MEMORANDUM

Project Name: Villebois Village Center Mixed-Use

Re: Development Review Board Public Comments

(DB21-0008, DB21-0010 through DB21-0013 Buildings A and B, 12C Lot 76;

SITE & LAND USE PLAN ALTERNATIVE

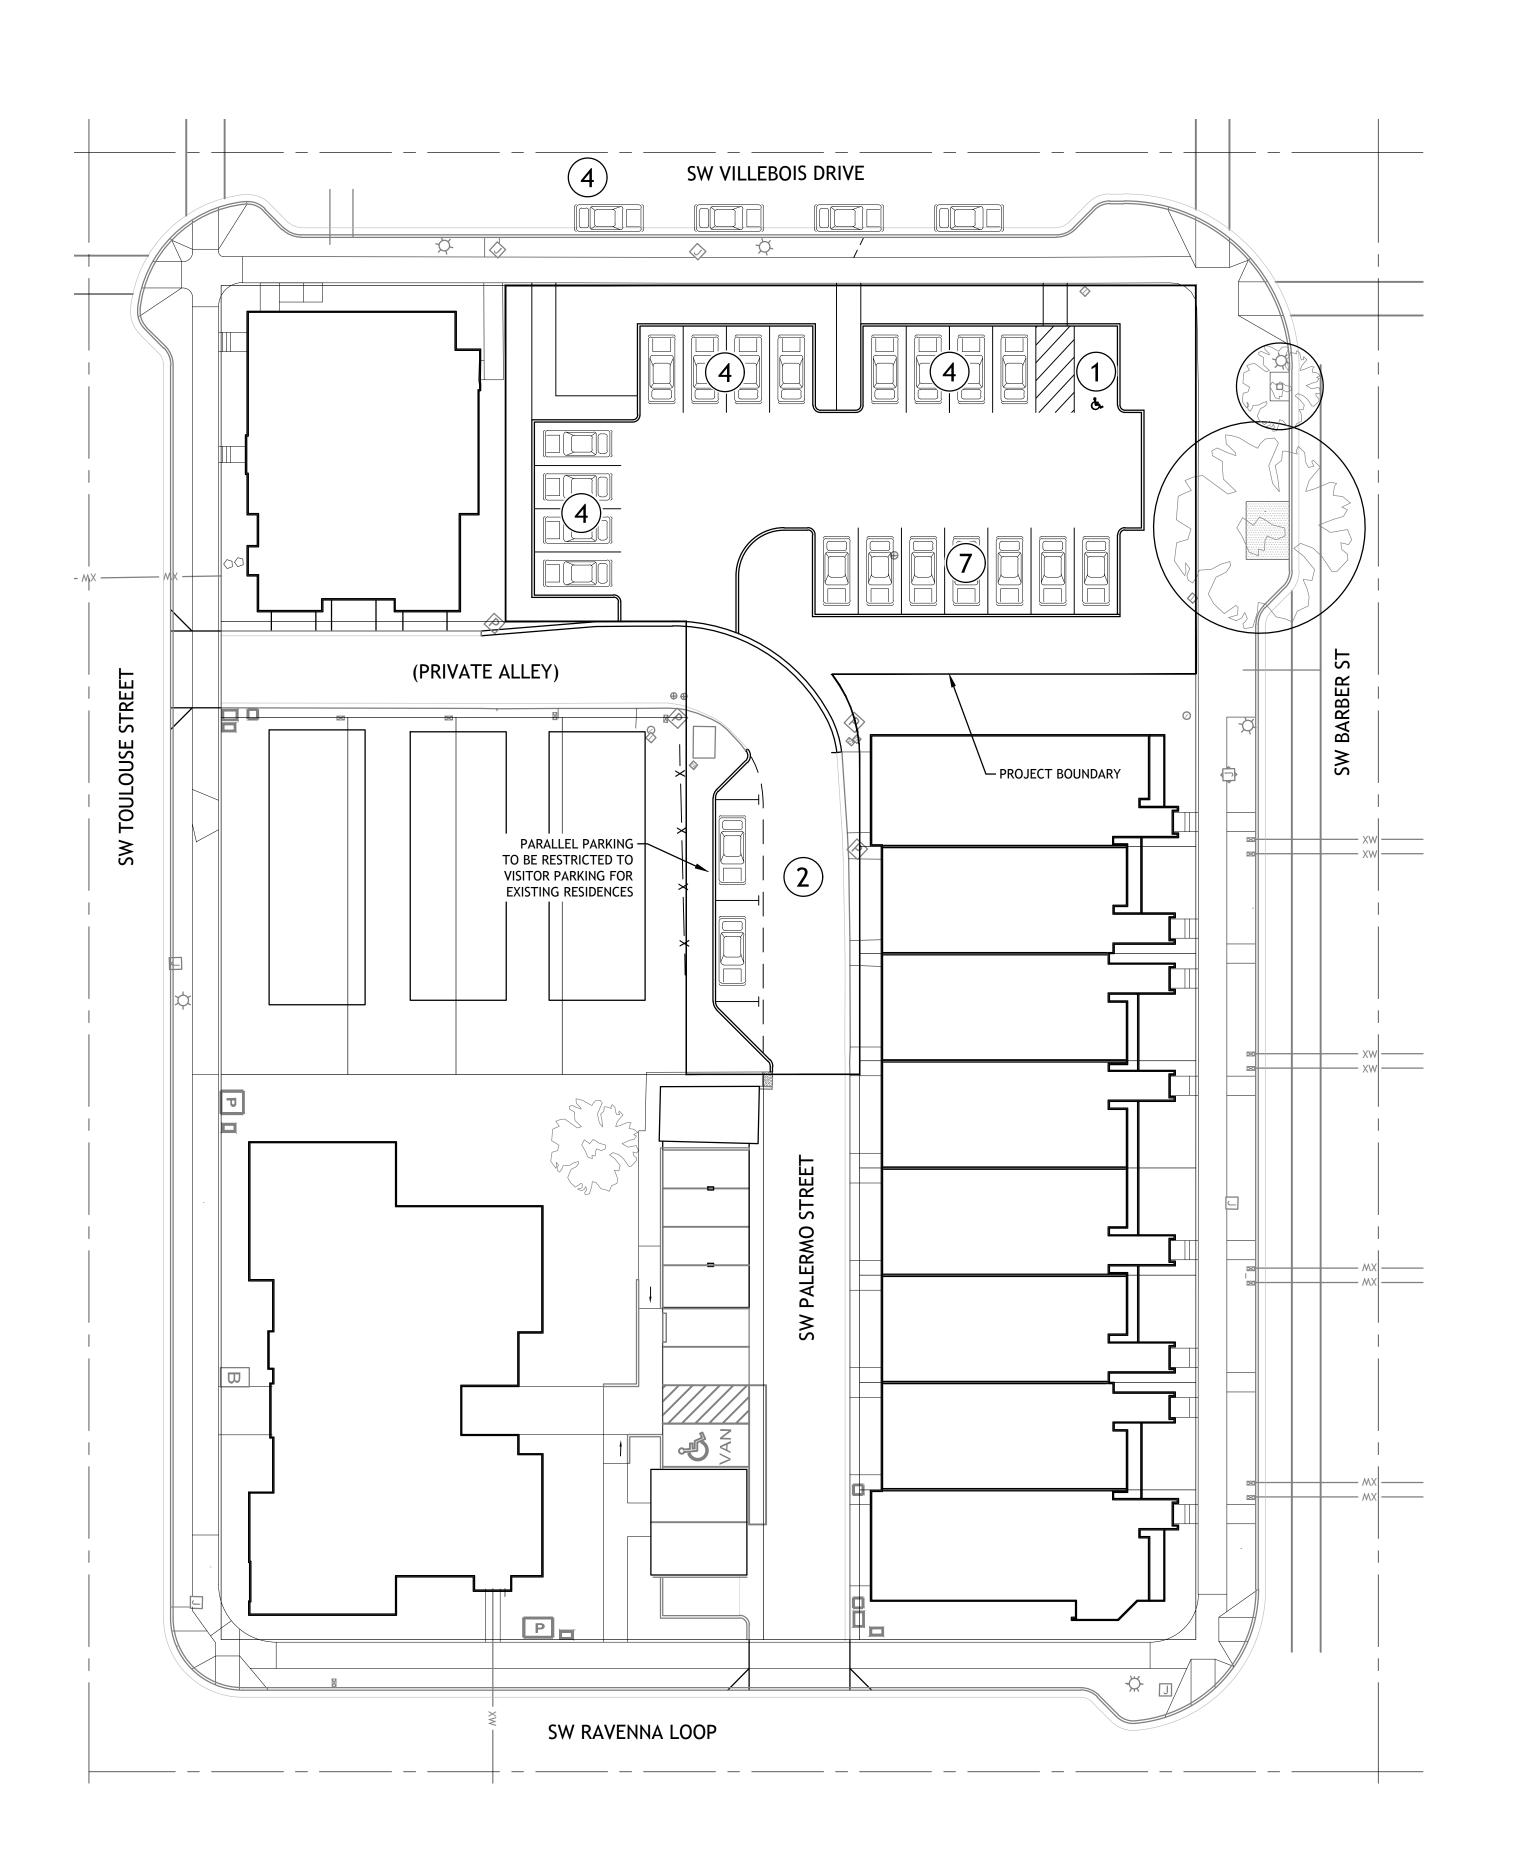
Has anyone measured the alley?

Poorly Planned Access

In order to further ensure that the parking spaces do not extend into the drive aisle, the applicant is proposing to redesign the alley parking spaces to provide two (2) parallel parking spaces as illustrated on the attached Preliminary Parking Plan Alternative exhibit.

The alleyway that serves Lot 12 is privately owned with a public access easement. As previously stated, the applicant does accept staff's suggested Condition of Approval DRB 1. and proposes to redesign the alley parking spaces to provide two (2) parallel parking spaces as illustrated on the attached Preliminary Parking Plan Alternative exhibit to increase safety in the alley.

> Preliminary Development Plan

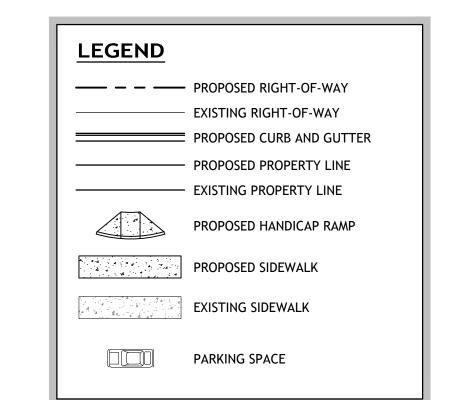
Bus Stop

The applicant has confirmed with staff that the height of the vine fence around the parking area on Lot 12 can be reduced to 5 feet (from 6 feet originally proposed). Reducing the fence by a foot will further enhance visibility into and out of the parking area while not compromising the screening provided by the vine fence. The vine fence is proposed instead of a solid wood fence for the purpose of providing screening, yet also allowing for some visibility for safety of all residents. There are pedestrian access openings along the Villebois Drive frontage which also increase visibility into and out of the parking area. Additionally, the applicant has redesigned the corner of Villebois Drive and Barber Street to pull the vine fence in and provide space for the location of benches as seen on the attached Landscape Plan Alternative.
